UNITED STATES PATENT AND TRADEMARK OFFICE

10/823,355

Office Action Summary	Application No. 10/823,355	Applicant(s) MARTINSON ET AL.	
	Examiner MICHAEL BAND	Art Unit 1723

DETAILED ACTION

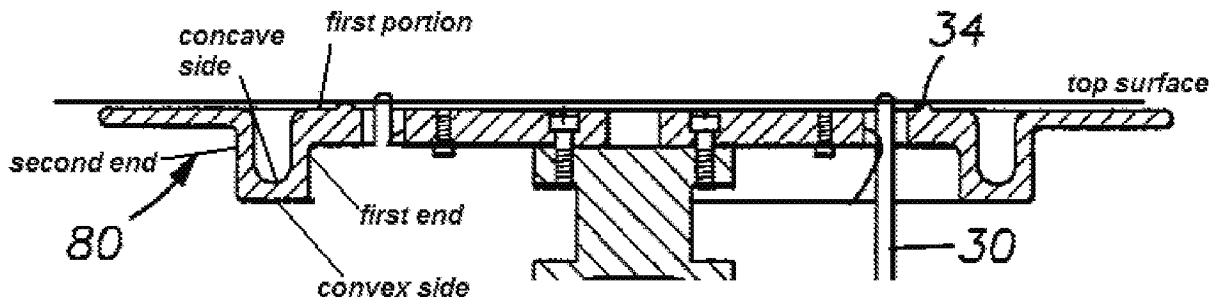
With respect to claims 38-40 and 43, Ref1 discloses an apparatus for full wafer deposition with a shield arrangement that prevents deposition in the area of a chamber surrounding a substrate (i.e. wafer) (abstract), where fig. 5 depicts a sputtering target [70] facing a pedestal [80] that is moved from a loading (i.e. lowered) position and a raised (i.e. processing) position. The pedestal [80] has a bump (i.e. representative of top

surface plane) [34] where a pedestal shield extends from said bump [34], where a first portion extends a first distance from said bump [34] away from said pedestal [80] to a first arcuate portion having a first end, a second end, a concave side opening vertically towards a top of the chamber, and a convex side, where said first end extends from said first portion with said pedestal shield residing below a top surface plane of said pedestal [80]. The cropped figure below of fig. 5 serves to further clarify the pedestal and pedestal shield.

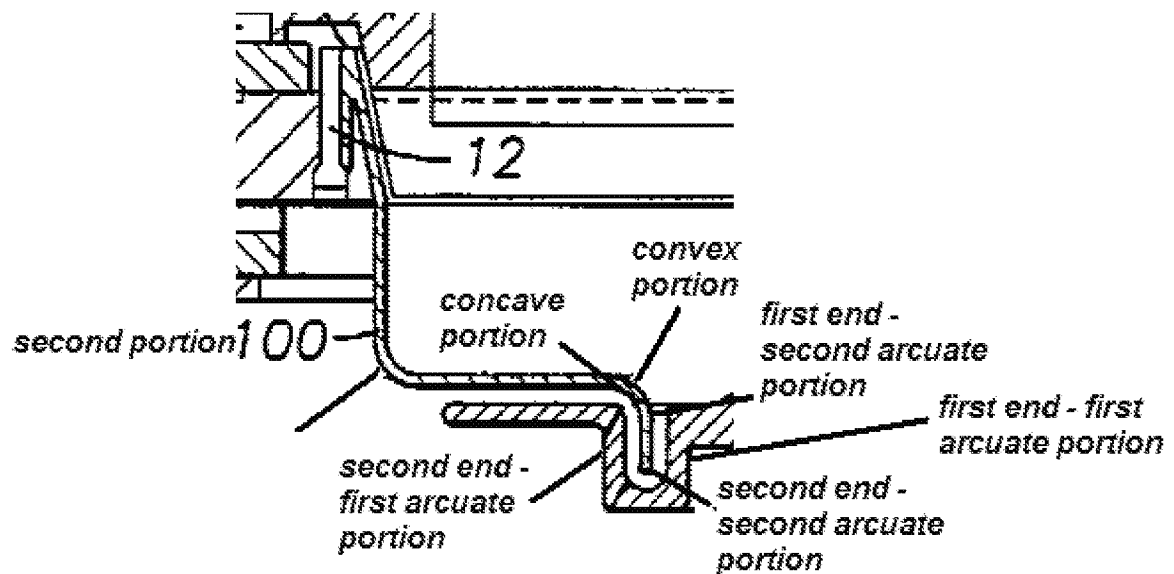
Fig. 5 further depicts a sidewall shield [60] comprising a second portion [100] extending downward from an upper portion of the chamber, and a second arcuate portion having a first end, a second end a concave side, and a convex side. Fig. 5 also depicts the concave side partially opening vertically towards a bottom of the chamber, where when the pedestal is raised into the processing position via lifter [90], the second end of the first arcuate portion is positioned vertically above and between the first and second ends of the second arcuate portion and the second end of the second arcuate portion is positioned vertically below and between the first and second ends of the first arcuate portion. Fig. 5 also depicts the second end of the first arcuate portion spaced approximately even between the first end and second end of the second arcuate

portion, and the second end of the second arcuate portion is spaced approximately even between the first end and the second end of the first arcuate portion. The cropped figure below of fig. 5 serves to further clarify the sidewall shield.

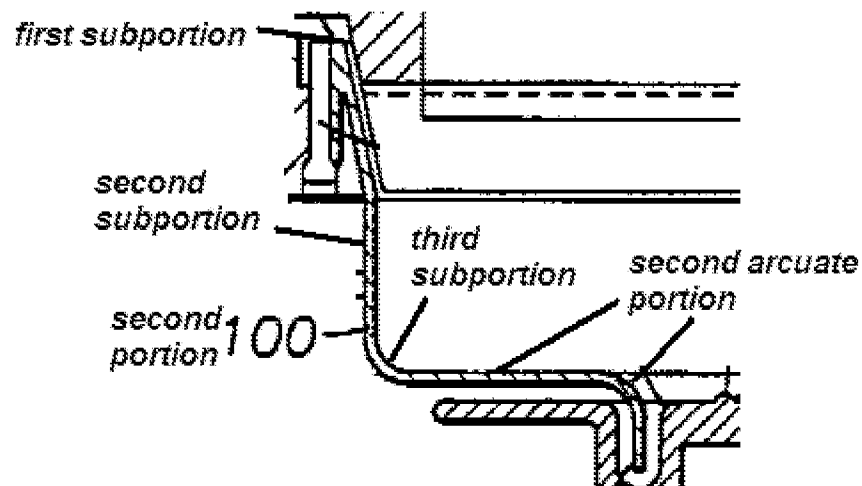
With respect to claim 41, modified Ref1 further discloses in fig. 5 the second portion of the sidewall shield [60] includes a first subportion extending horizontally inward of the chamber, a second subportion extending vertically downward from said first subportion, and a third subportion extending horizontally inward from said second subportion, wherein the second arcuate portion extends from said third subportion. The cropped figure below of fig. 5 serves to further clarify the subportions.
